RAI: Volume 3, Chapter 2.2.1.3.4, First Set, Number 9, Supplemental:

Justify the use of high-temperature Pu solubility experimental data in fitting the adjusted-Eh Pu solubility abstraction as it applies to all repository thermal conditions.

Figure 2 Comparison of Ambient Temperature Experimental Data to the Predicted Plutonium-Solubility Model Using the Adjusted-Eh Solubility Model, Equation 2 to Calculate Eh

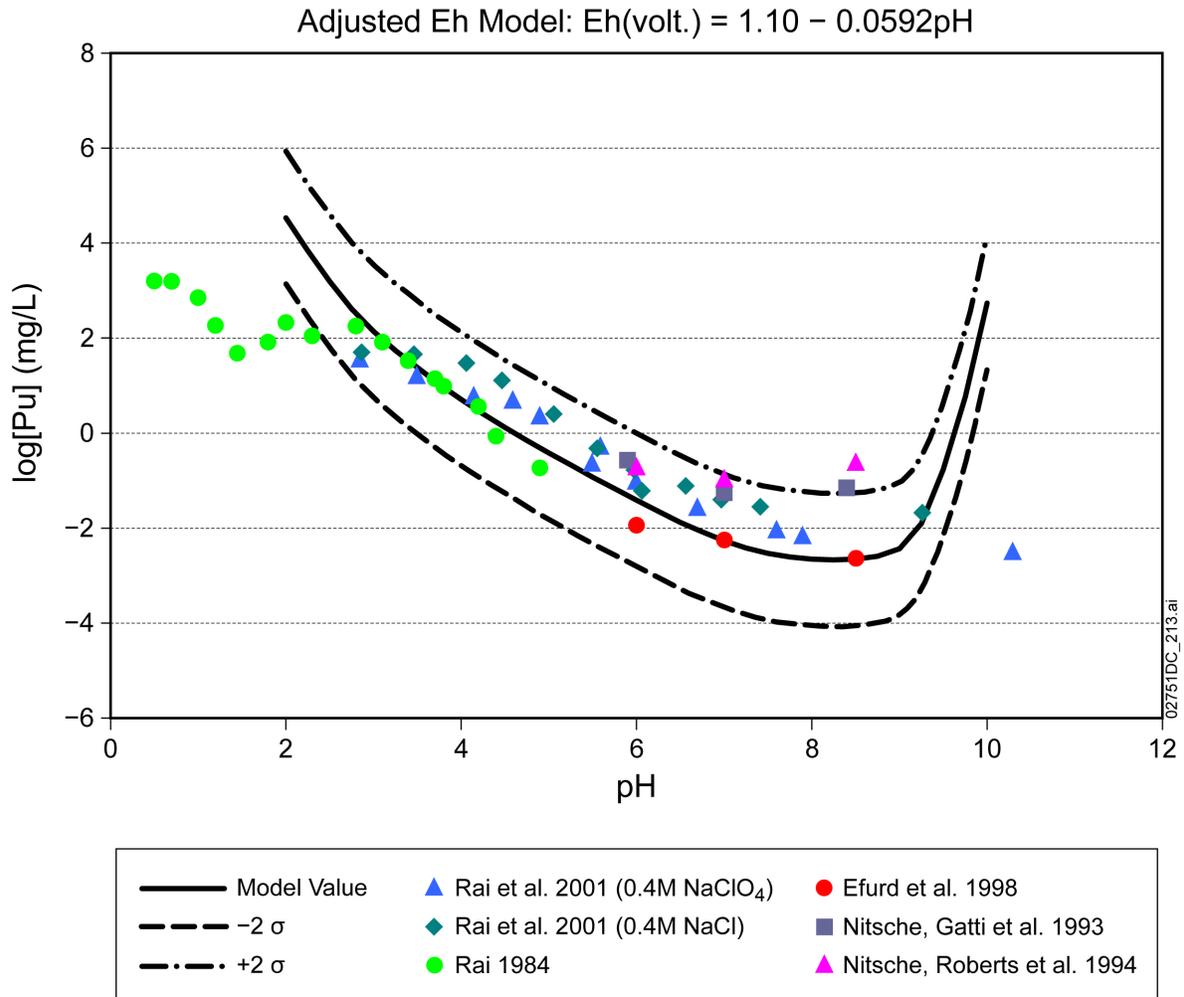
Basis: The Eh-pH equation used in the adjusted-Eh abstraction for the Pu concentration limit was selected so that the resulting curve of Pu concentration versus pH passes through a set of published Pu solubility experimental results (SAR Figure 2.3.7-37). Some of the data used in SAR Figure 2.3.7-37, however, were obtained at temperatures of 60° and 90° C (Nitsche, et al., 1993, 1994; Efurud, et al. 1998), which are higher than long-term conditions in the waste package. For Pu, higher temperatures result in lower solubility limits (SNL, 2007a, Section 6.3.3.3) and therefore lower release rates. The high-temperature data, therefore, may inappropriately skew the range of experimental data to lower values. Without the 60° and 90° C results, nearly every data point in SAR Figure 2.3.7-37 falls above the mean curve that was apparently fit through the data. The requested information is needed to verify compliance with 10 CFR 63.21(c)(11)-(15) and 63.114(a) and (b).

As discussed in SAR Section 2.3.7.10.3.1, the adjusted-Eh solubility model uses Eh calculated as shown in Equation 2. This adjusted-Eh equation was derived by adding 0.06 volts to the calculated Eh value given in Equation 1 for pH values between 3.2 and 12. The rationale for adding 0.06 volts is that measured Eh data from Rai (1984) are about 0.06 volts higher than values obtained from Equation 1. Thus, the Rai (1984) data that are measured at 22°C were used to fit the adjusted-Eh plutonium solubility model.

Using the adjusted-Eh solubility model, most of the data points from the solubility experiments fall within the uncertainty range of the adjusted-Eh solubility model, as shown in Figure 2. As requested by the NRC, Figure 2 (from SAR Figure 2.3.7-37) has been created without the high-temperature data. Note, there is no change to the modeled plutonium solubility results due to the fact that the high-temperature data were not used in the development of the adjusted-Eh solubility model.

In summary, the development of the adjusted-Eh solubility model is based upon experimental Eh data on natural waters, plutonium solubility, and speciation. The high-temperature plutonium solubility experimental data presented in SAR Figure 2.3.7-37 were not used for model development. Only data at 22°C reported by Rai (1984) were used to fit the adjusted-Eh solubility model. Thus, the adjusted-Eh solubility model appropriately represents the range of experimental data consistent with the long-term conditions in the waste package.
